**ALLSTAR PZL GLIDER**  
Sp. z o. o.  
ul. Cieszyńska 325,  
43-300 Bielsko-Biala  
tel.: +48 33 812 50 26  
fax: +48 33 812 37 39  
techsupport@szd.com.pl  
www.szd.com.pl

**SERVICE BULLETIN**  
**BE-063/SZD-50-3/2014 „PUCHACZ”**  
Allstar PZL Glider considers compliance mandatory

**SUBJECT:** Inspection of rudder cable fitting blocks

**Figure 1. Crack location**

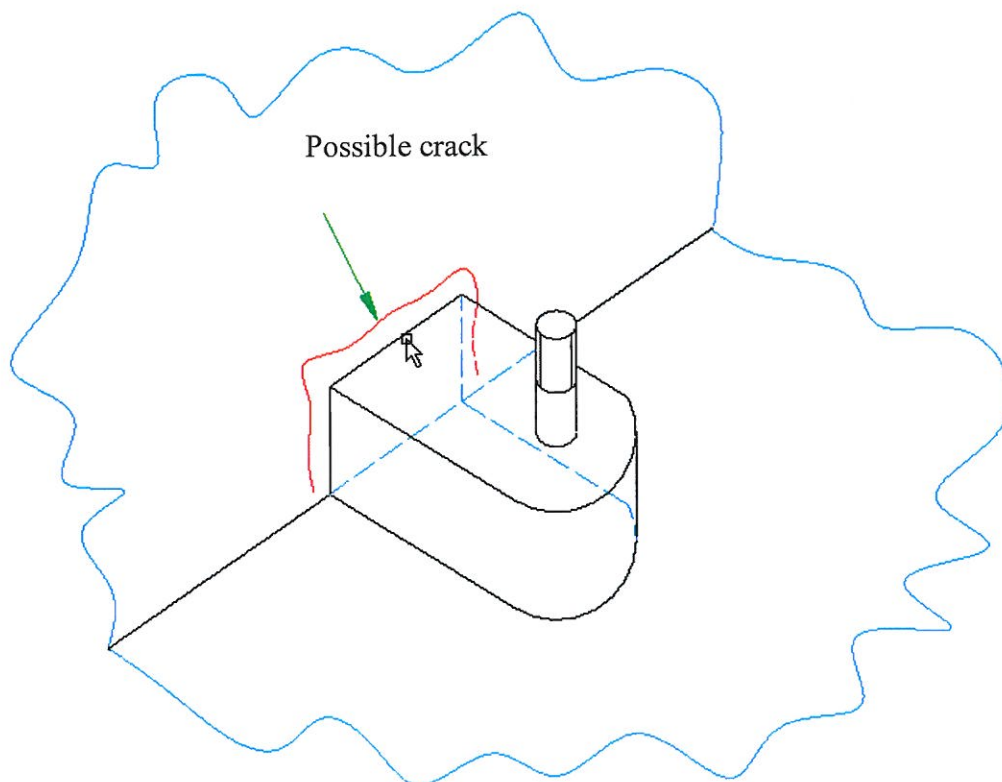
Immediately after receiving of this SB inspect the painting area around the block, in the place of fitting of the rudder cables and gluing to the fuselage's shell, close to the pedals: left and right (see Fig. 1). If found the crack, this is the sign of separating process of the block from fuselage's shell.

In case of crack's found in any places (left or right fitting), before the next flight, correct the fitting of both blocks to the shell. Follow acc. to the description in item 3.2 of the SB.  
In cracks do not appear, the glider may be exploited until the repair acc. to item 3.2 is to be performed.

**Figure 2. Procedure of repair**

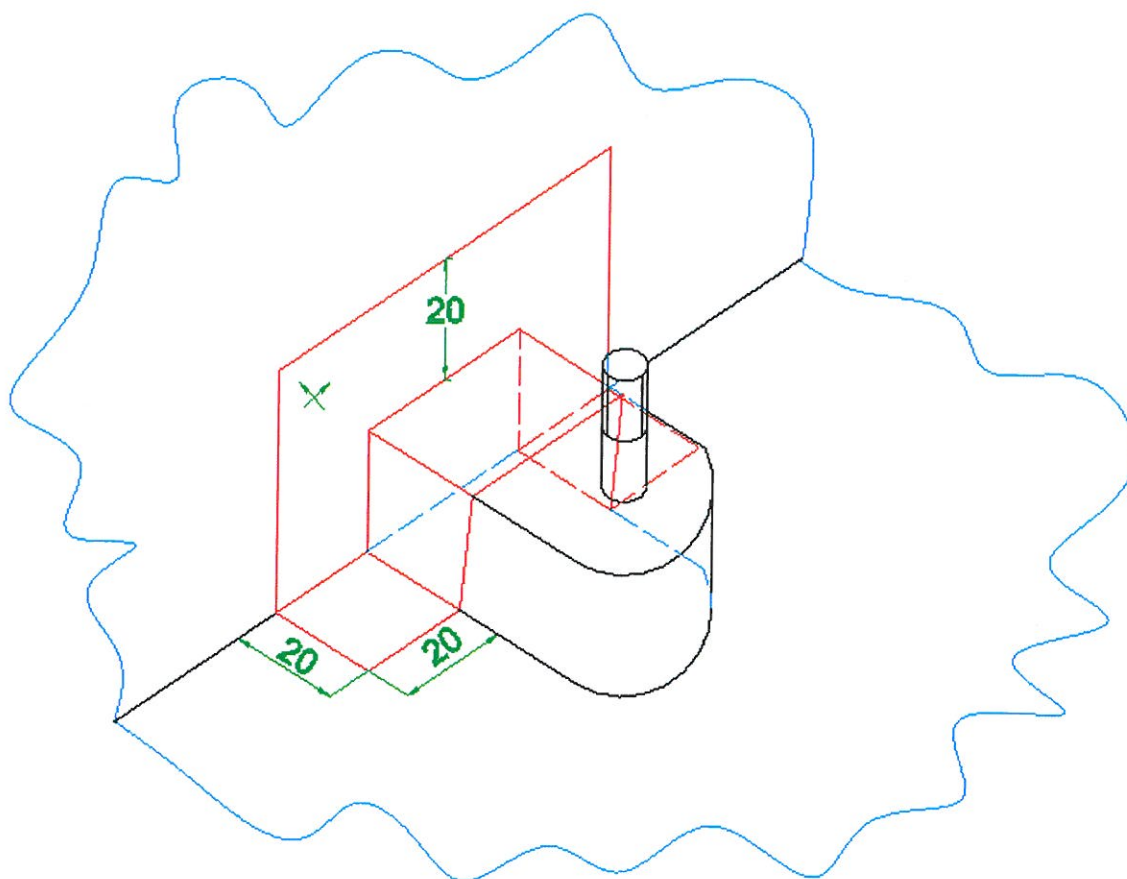
In the period of time up to 12 months from receiving of this SB, for ex. during the nearest annual inspection, the repair as below should be carried out, independently if the crack is found or not (as per attached Fig. 1).

Both blocks should be laminated into the fuselage's shell with angle fabric of 20 mm width, based on two layers of 92110 INTERGLAS chamfer fabric (see Fig. 2) and following the instructions enclosed in Repair Manual.
